SERVICE BULLETIN

Machines/Models: X Series
Work Platforms

SERVICE BULLETIN: 94.6, THE INSTALLATION OF THIS LABEL IS MANDATORY!

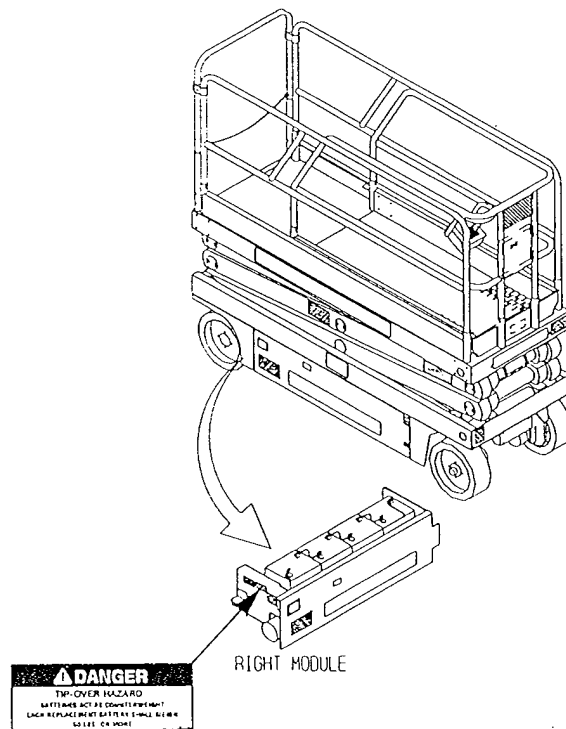
PURPOSE: Notification of requirement to install label.

OPERATION REQUIRED: Installation of one label.

PARTS REQUIRED: 62562-001.

PROCEDURE: Install label as shown in the following illustration.
